**DEVIATION REVIEW
 AND DECISION FORM**

Address of Subject Property (Street Number/Name): Not Available
 Tax Schedule ID(s) #:5500000135
 Legal Description of Property: W2 SEC 9-15-65, EX PT TO RDS
 Subdivision or Project Name: Springs at Waterview East

Section of ECM from Which Deviation is Sought: 2.3.2 Design Standards by Functional Classification

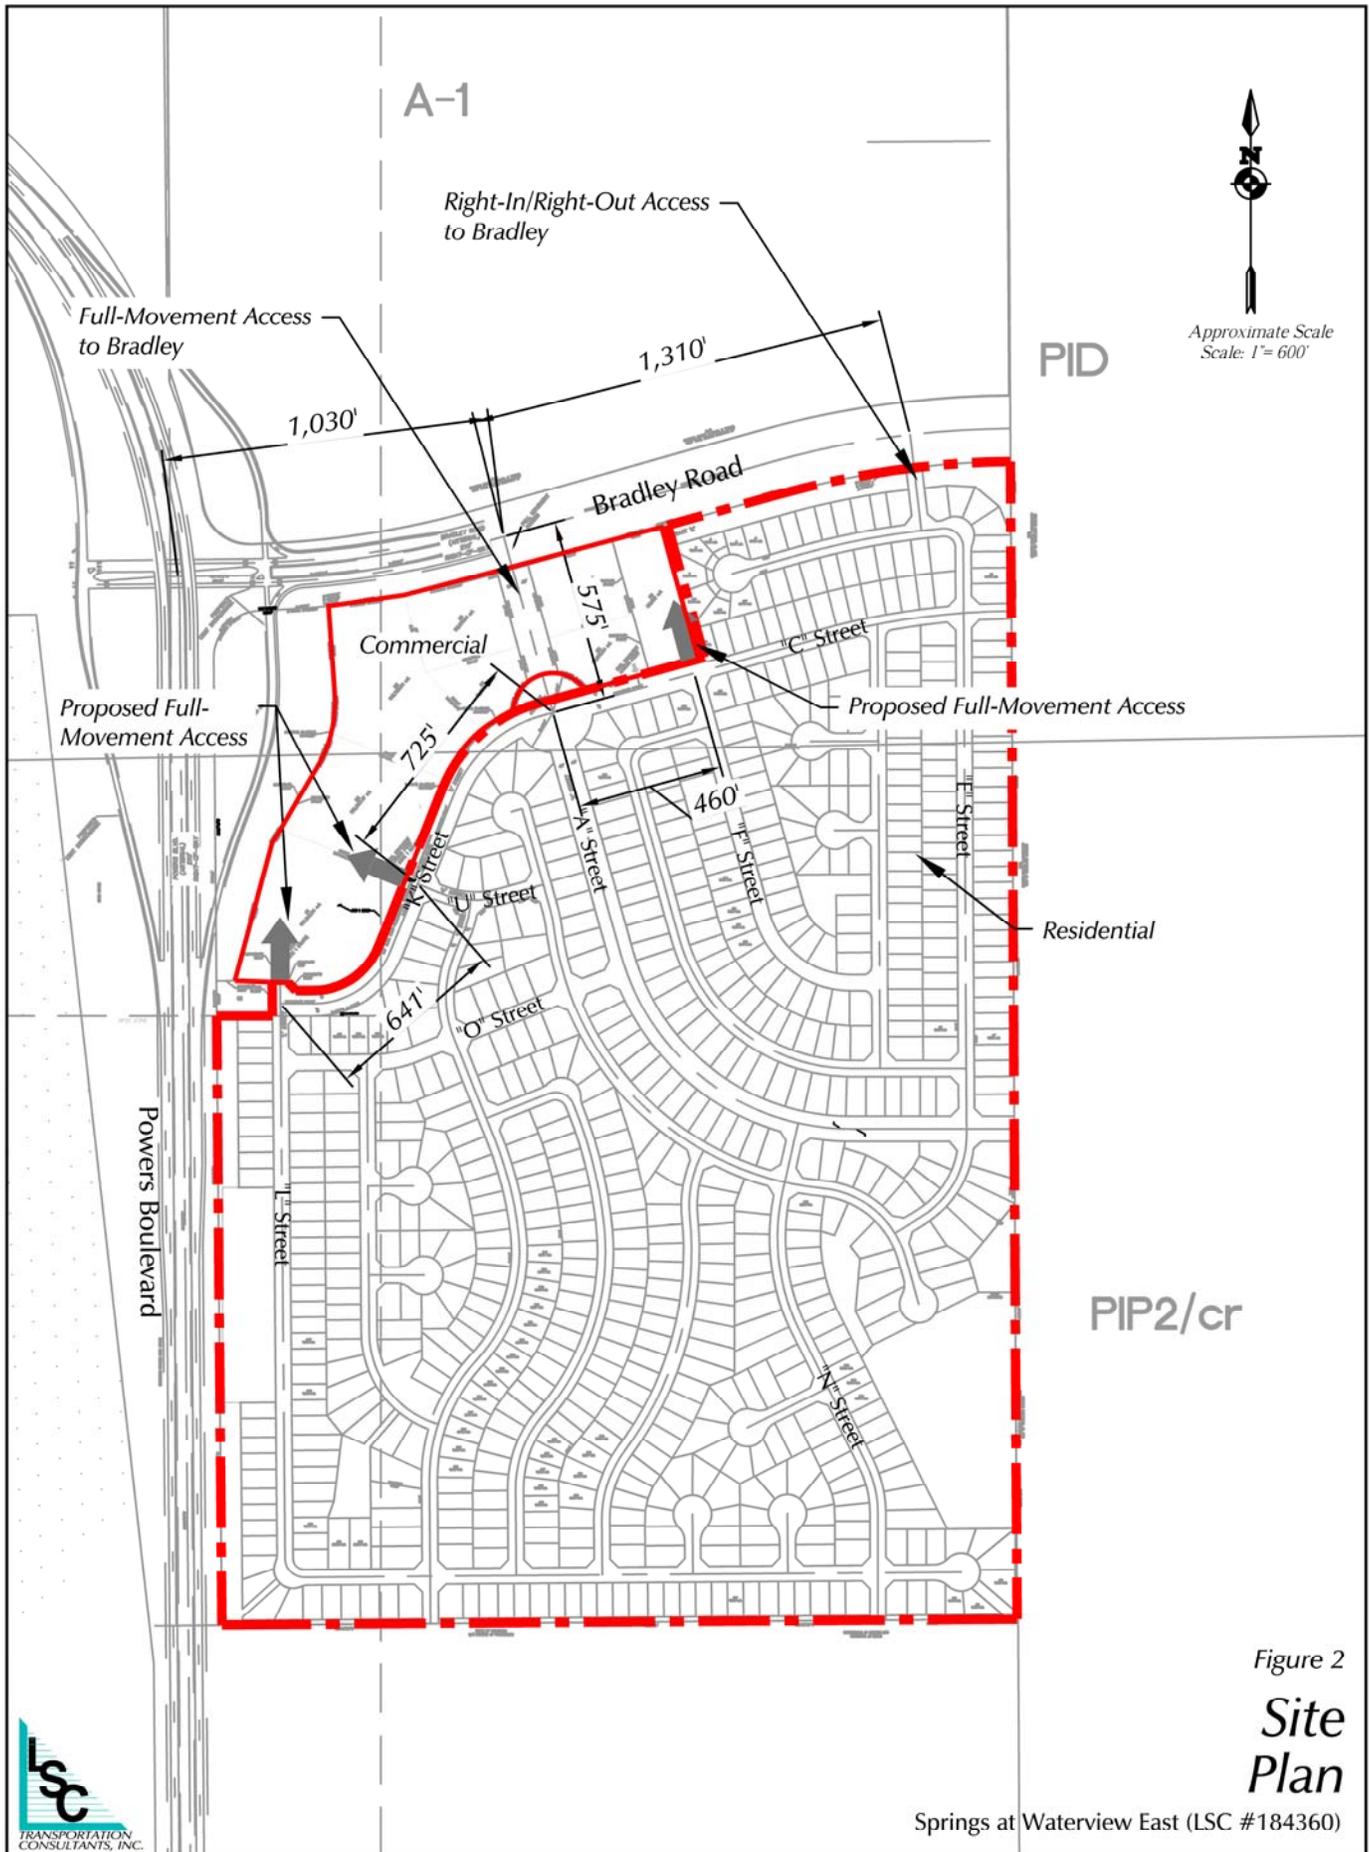
In general, why is the text referring to the A Street and Bradley Road distance by adding half of the ROW of Bradley? This makes the deviation confusing, if there is no reason, please change the entire deviation to read that the criteria is 660'.

I see no mention of the south bound movement on A street, please provide justification that the traffic leaving Bradley and proceeding south on A street will have no issues due to the shortening of this section of Road.

Figure 4

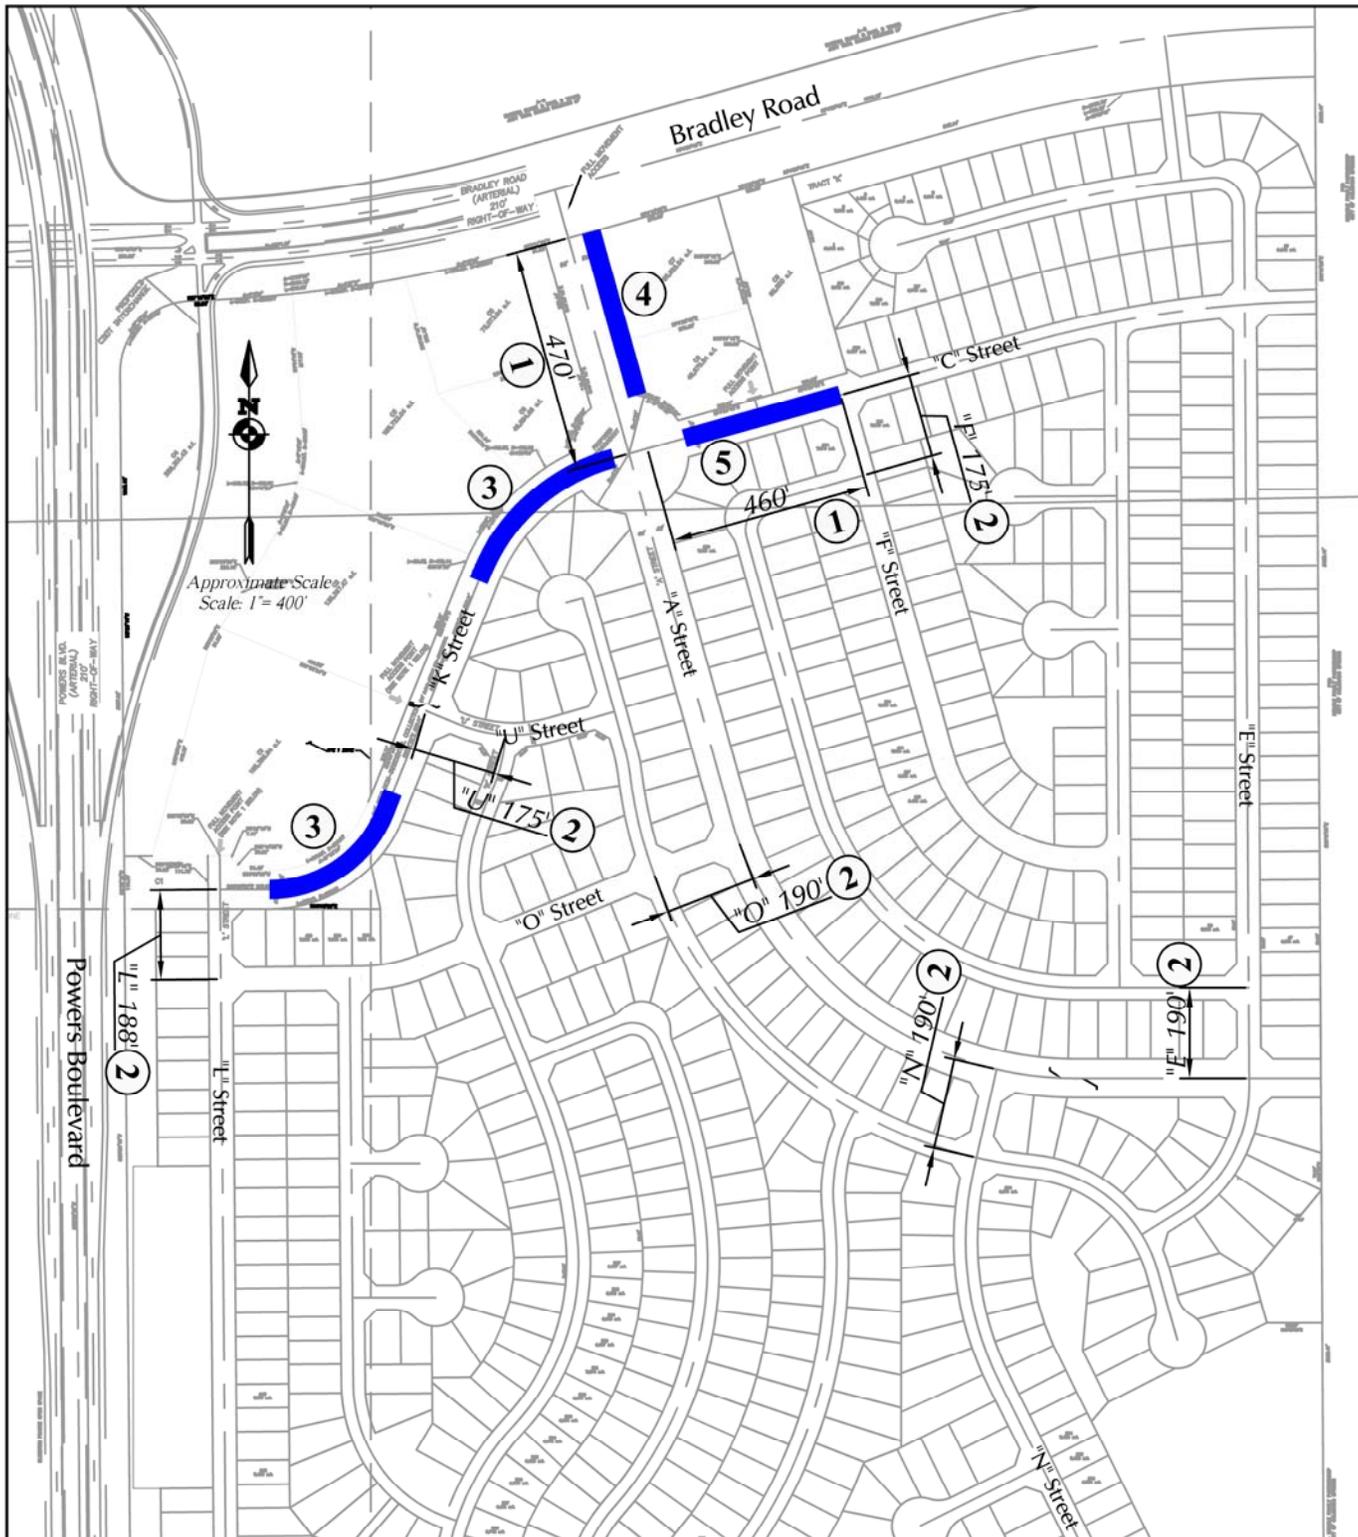
Comparison of Proposed Deviation to ECM Standard: The section of A Street between Bradley road and the roundabout is 575 feet, or 190 feet short of the criteria (ECM standard -765 feet); C Street east of the proposed center of the roundabout to the commercial access is 460 feet or 200 feet short of the criteria (ECM standard - 660-foot minimum).
